January 12, 2017

Re: Marriott Residence Inn and Employee Apartments – Changes to Plans since January 3

REF-03 - Existing Design / New Design

Revised January 17th - 48 Ft. Height Plane Diagram

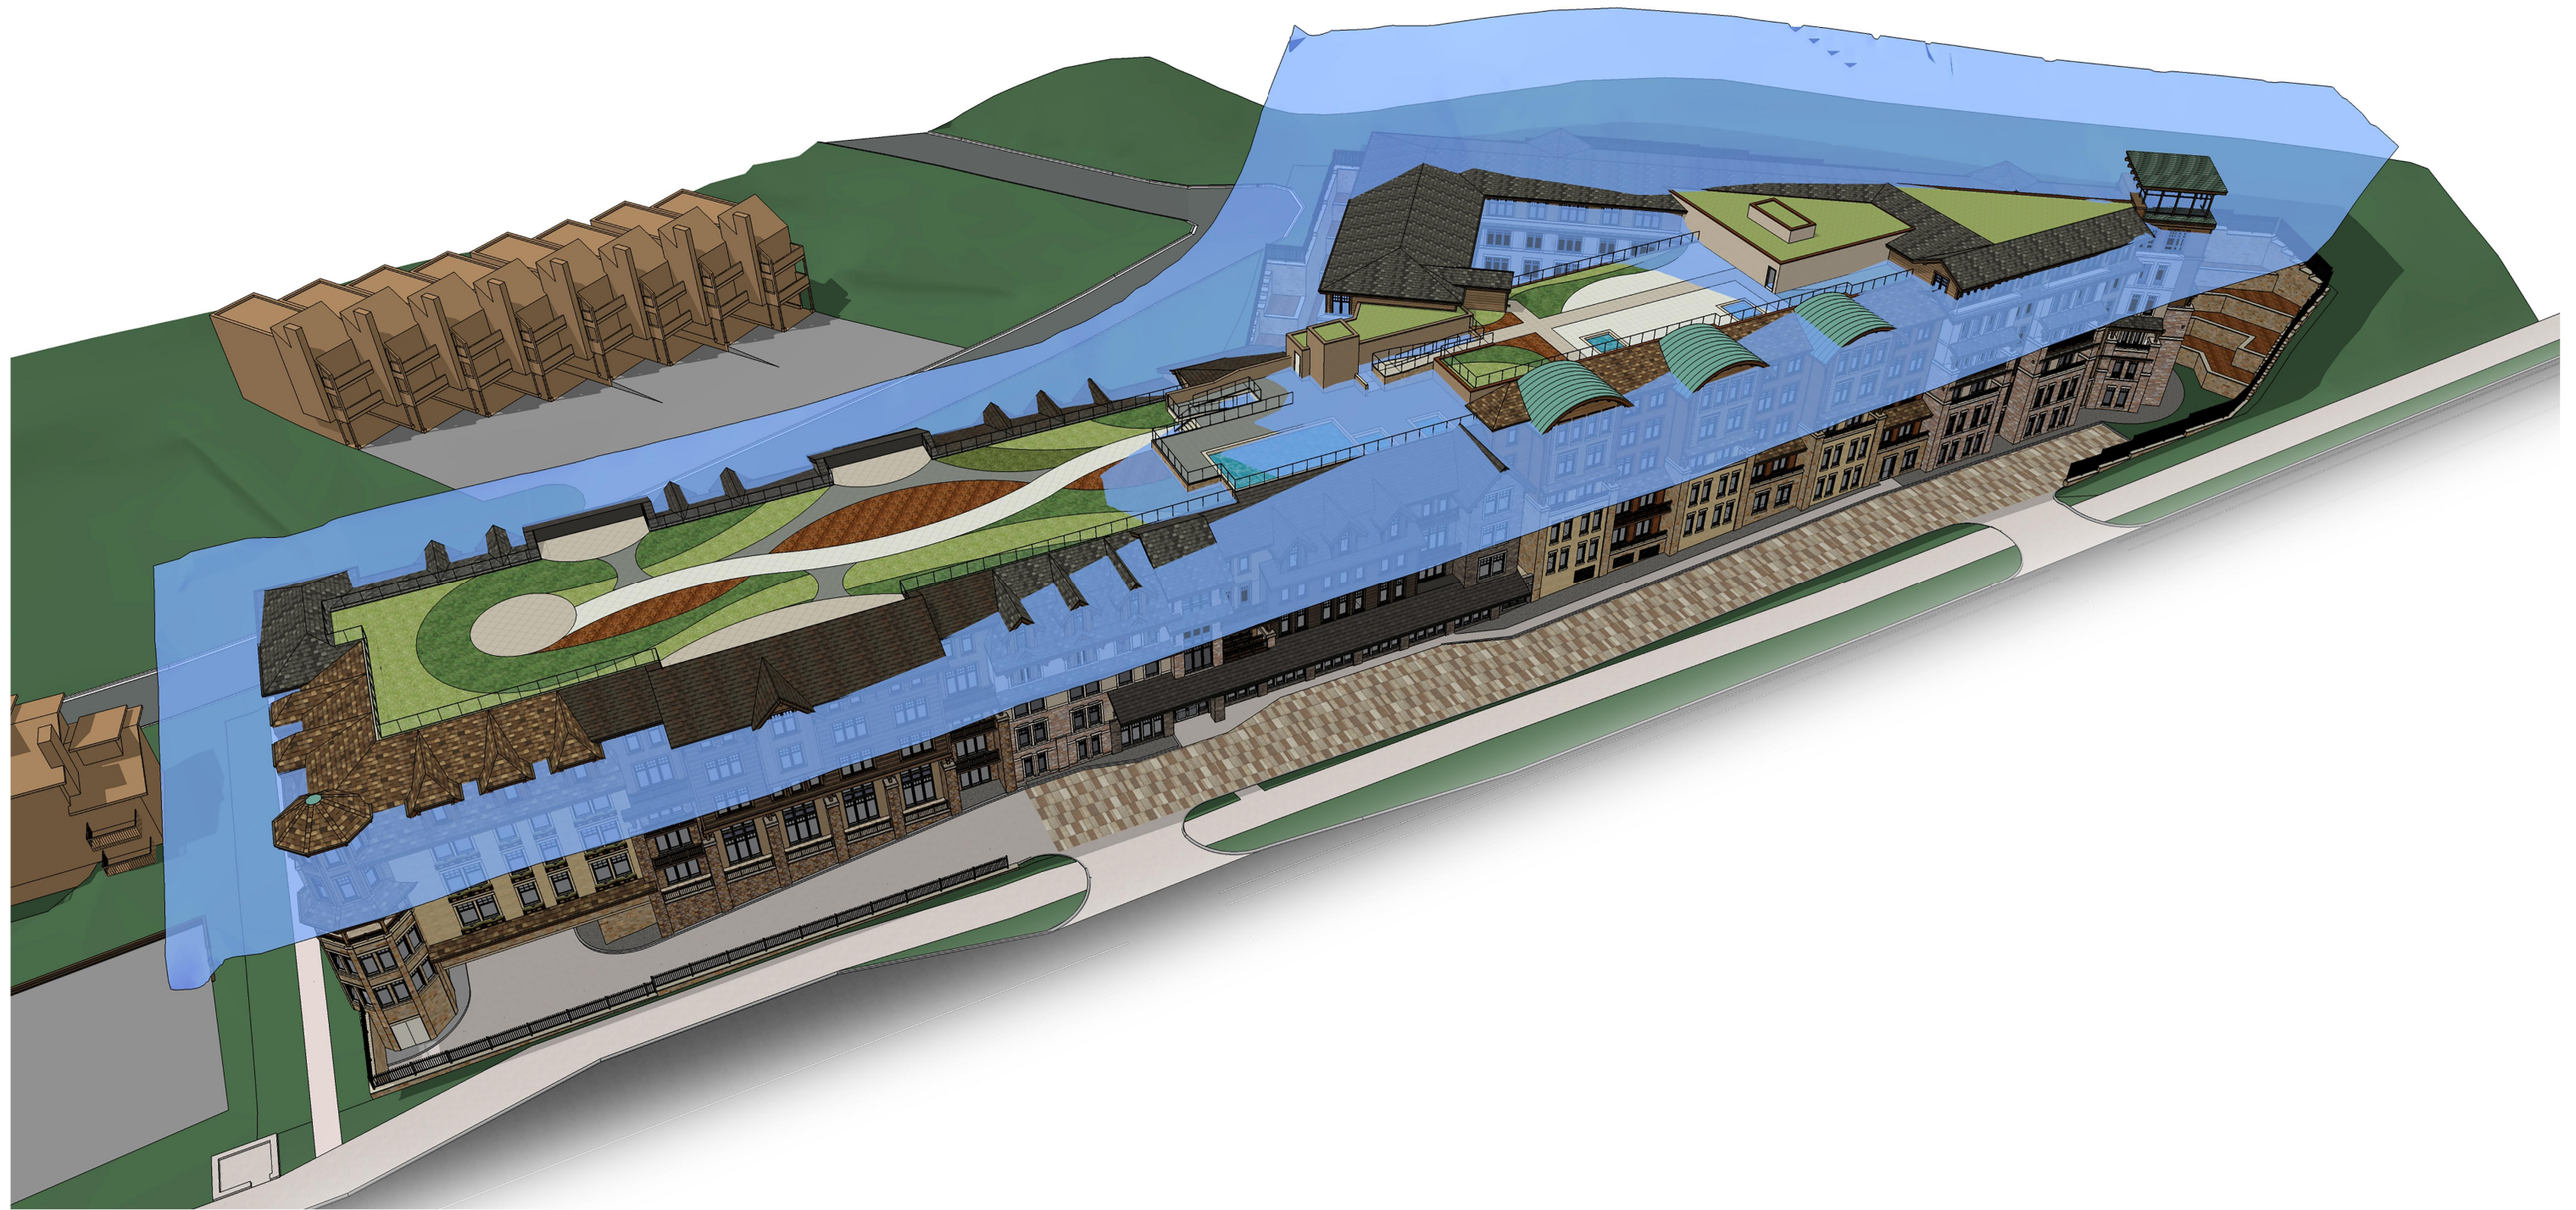
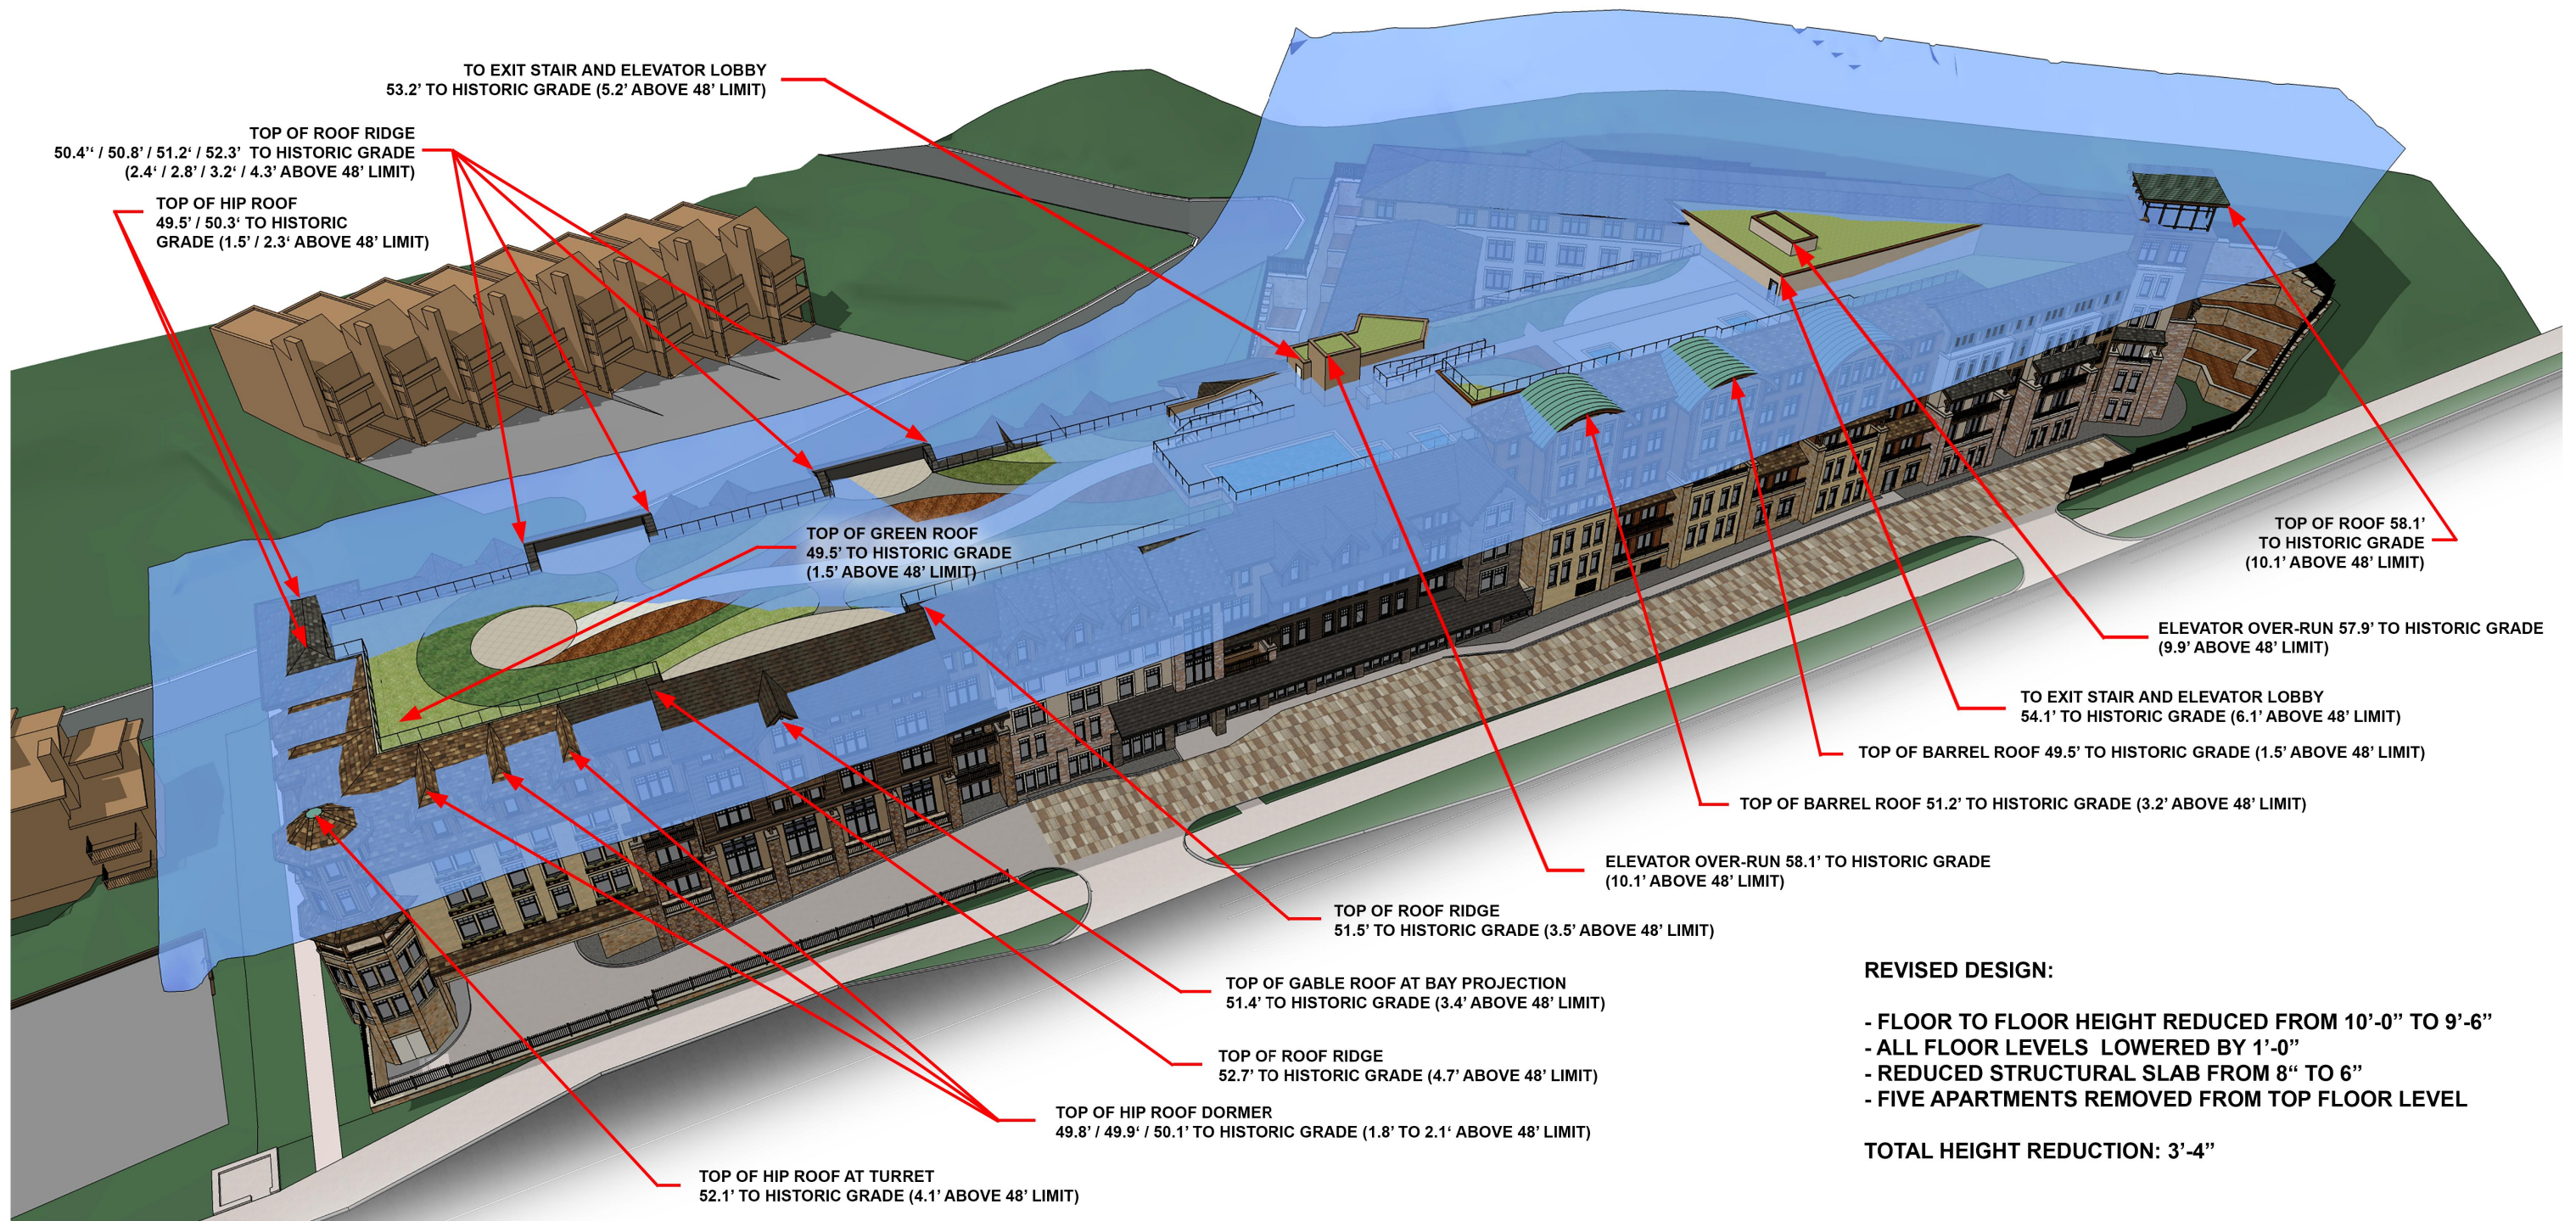
1. **Building Height Lowered.** The plans have been revised by lowering the overall building another 3'-4" (aka 40"). This was done by pushing the entire building into the Earth another foot and also by changing the construction methodology such that the floor to floor depth was reduced by another 2'-4" (aka 28"). This change brought the west half of the building almost completely under 48'. There are a few roof forms and a portion of the green roof that project above the 48'. In order for the west half of the building to be under the 48' (except for allowed architectural projections such as stair towers, elevator towers, and related spaces), the mass and floor area of 5 employee housing units had to be removed from the middle/rear of the building and the front (south elevation) of the building. The removal of these 5 employee housing units caused the other 6 employee housing units on the upper level adjacent to the hillside to the east to be eliminated as separate units. This was due to life safety exiting requirements for those spaces. The floor area of those 6 employee units were added to 6 units on the floor below allowing for two story units with internal circulation. The result are 6, 4-bedroom units. See the diagrams attached showing the height, location of remove mass, revised elevation, and comparison the to previously approved hotel (2013).

2. **Reduction in Building Mass.** As explained above, 5 employee housing units were removed from the upper level of the building in order to be under the 48' height limitation. This change removed bulk and mass from the project in addition to the lowering of the building.
